TECHNICAL EVALUATION REPORT

HYDROLOGICAL CONSIDERATIONS

INSERVICE INSPECTION OF WATER CONTROL STRUCTURES
COMMONWEALTH EDISON
DRESDEN NUCLEAR POWER STATION UNIT 2

NRC DOCKET NO. 50-237

Figure 1. Water Control Structure Location

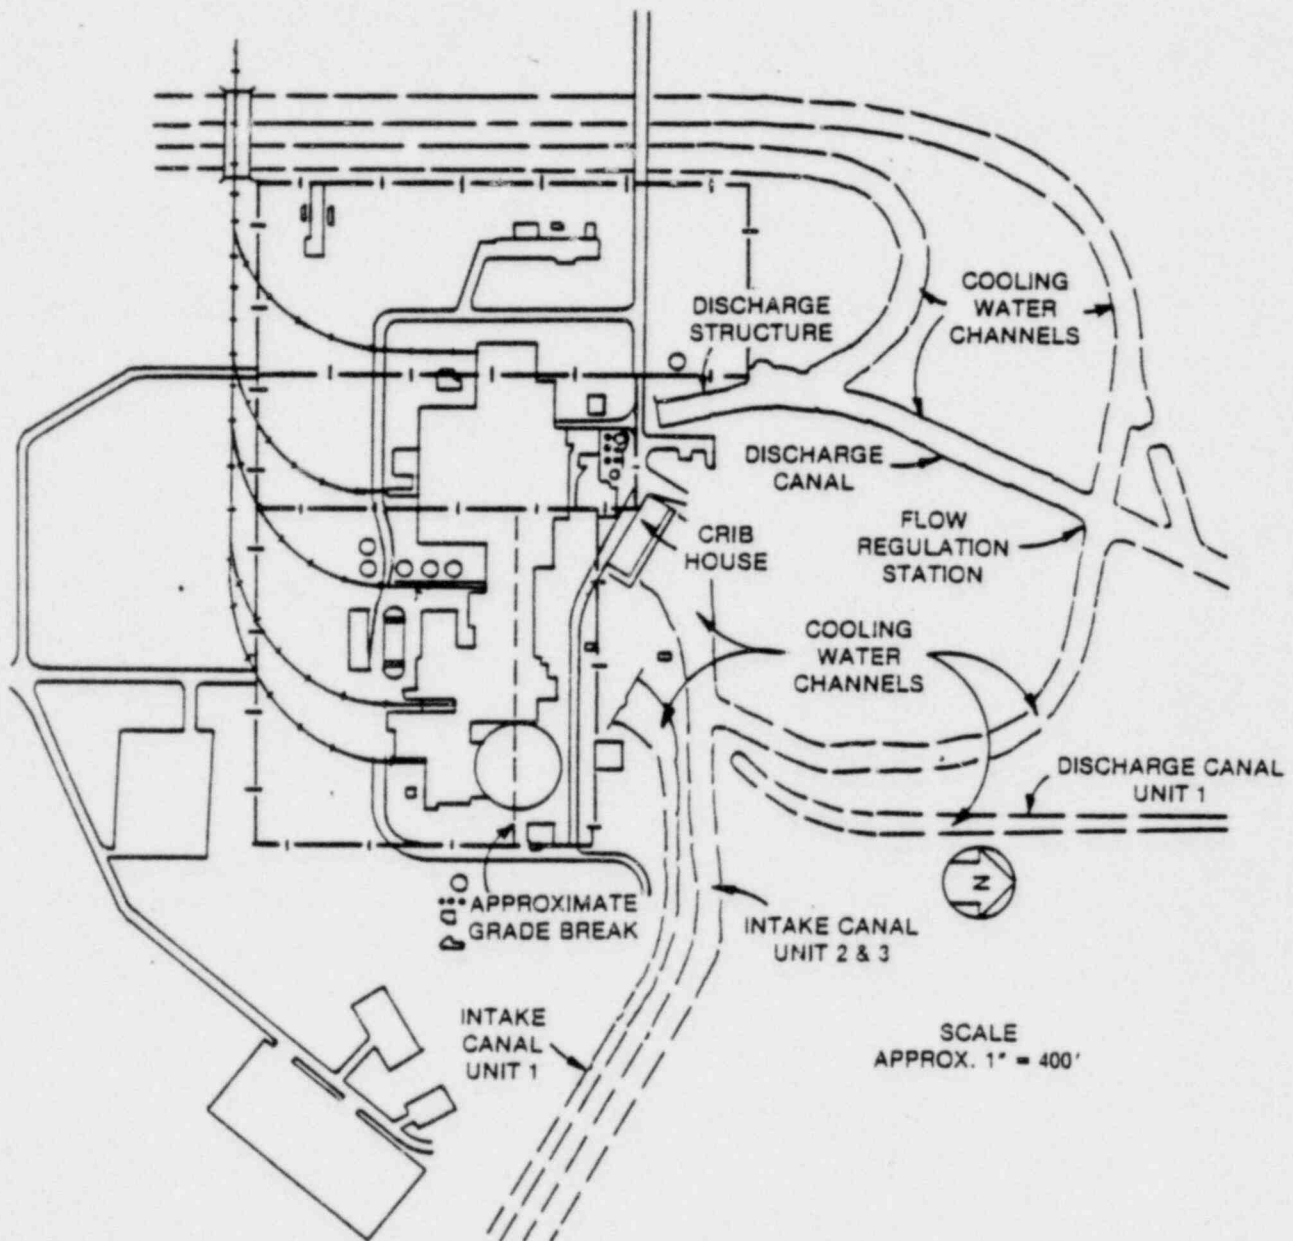
The Licensee presents two items under flood control structures which are not necessarily flood water control structures. The doors at plant grade are not flood-proofed and will not act to preclude flood waters from entering the buildings and thus should not be considered flood water control structures.

The water level gage is not used to control floods, but to monitor them. The issue of whether the canal water level gage should be inspected is not disputed; however, its placement under the category of flood water control structures is unnecessary.

The roof drainage system was identified in SEP Topic II-3.B (Flooding Potential and Protection Requirements) as a water control structure and could be included in the Licensee's inservice inspection program for water control structures. During integrated assessment, other water control features may be identified which should also be included in the Licensee's formal inservice inspection program.

The frequency of inspecting the intake and discharge structures for structural integrity should depend on considerations other than "depending on observed sedimentation rate," as specified. Frequency of inspection should be based on historic occurrences of settlement, cracking, sinking, or other movement which may influence the stability of these structures.
